APPLICATION

SEWAGE DISPOSAL TESTING

NEW HOUSE TO TIE

INTO EXISTING SEPTIC SYSTEM

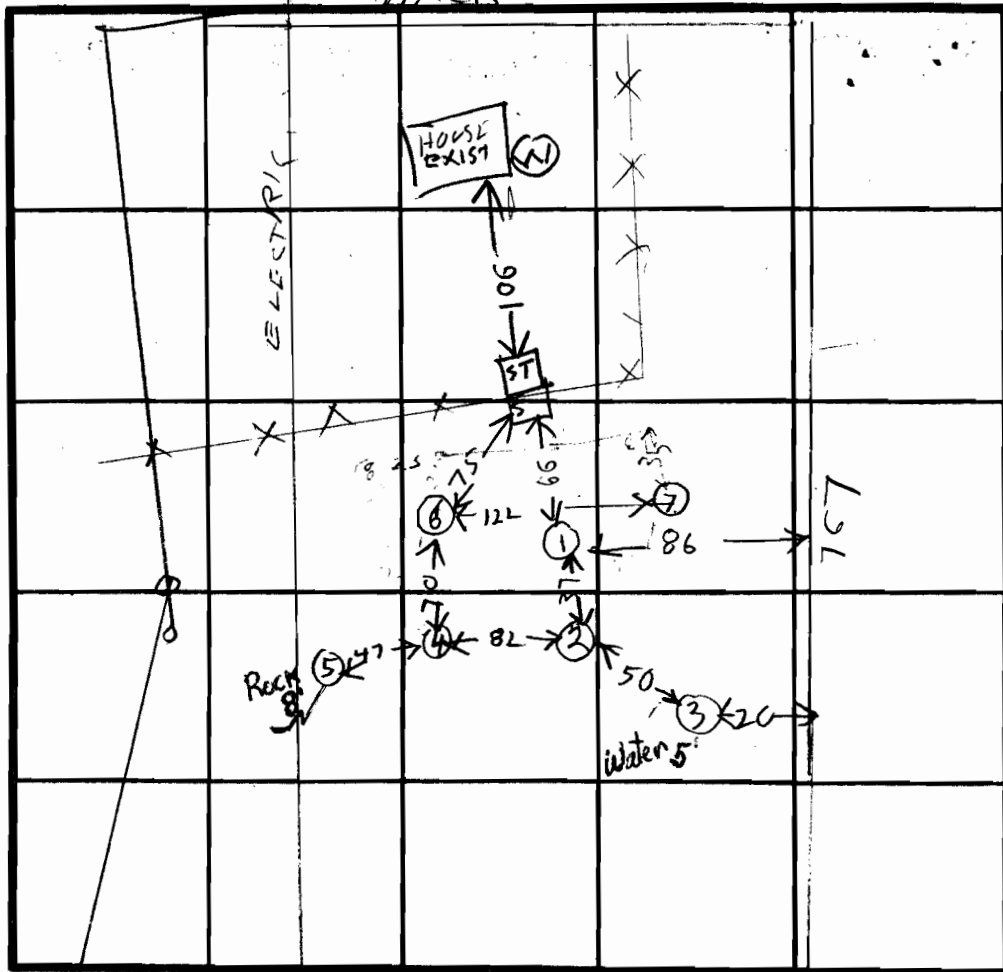
PLANS MUST SHOW LOCATION & ELEVATION OF NEW HOUSE & HOW IT CONNECTS WITH EXISTING SEPTIC SYSTEM ALSO SHOW LOCATION & ELEVATION OF WELL

10/15/79 HOLD MUST CHECK RECORD OF PREVIOUS

PERC, & ALSO WATER ON LOT MUST CHECK WITH DCM

REMARKS SOIL IN GENERAL SIMILAR TO HOLE ①
WATER HOLE ③ IS 6 FT LOWER THAN HOLE ②

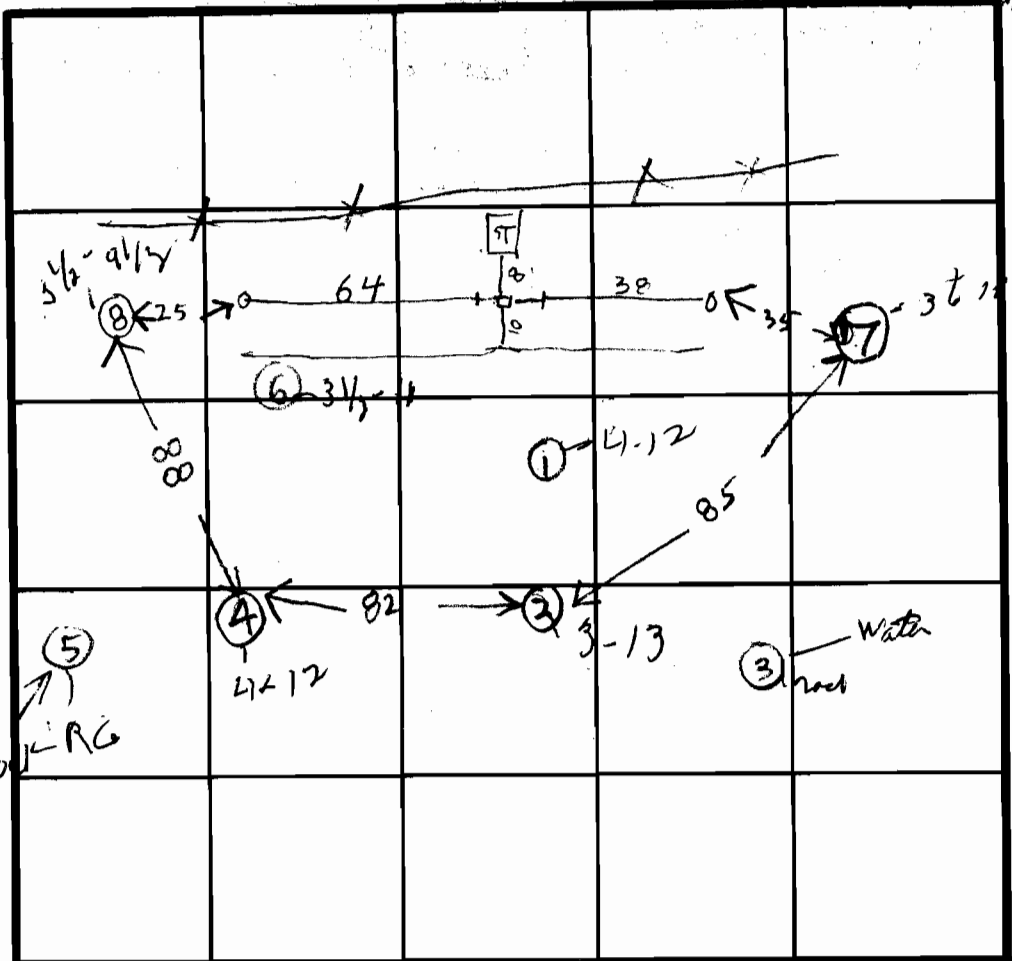
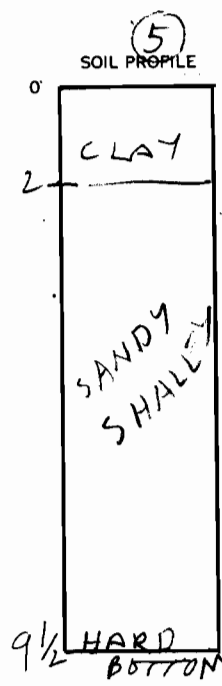
AT LEAST 10 FT BEHIND TANK
WATER IN SOME PLACES ALL 10/31/79 DM SAID PERC
OK 10/12

1/2/31/79 - Plans Rejected

① Too much slope from House to Tank

② I thought the House was supposed to be connected to the existing tank & Drainsfield instead of putting in a new Dry Well

① Show elevation of sewer pipe where it enters tank & where it enters ditch. (Must show .3 ft drop going through tank & must be 0.2 ft to 0.4 ft drop going from House to Tank)

② Pipe must enter ditch 2 ft below original grade

③ Indicate whether or not ground to be cut or

④ ^{billed} show ground elevation at tank over

4 Bedrooms - An extra Ditch
3 ft wide 4 ft deep and
70 ft long filled with 2 ft
of stone to be dug 10 ft
from and parallel to the
2nd ditch of the existing system
Connect the extra ditch to the 2nd ditch

5 Bedrooms - 2 Extra Ditches
The first extra ditch to be
exactly as required for the 4
Bedroom house. The 2nd
extra ditch to be 3 ft wide
4 ft deep and 70 ft long
filled with 2 ft of stone
The 2nd extra ditch is to
be 10 ft from & parallel
to the first extra ditch

Revised plans OK R.H.
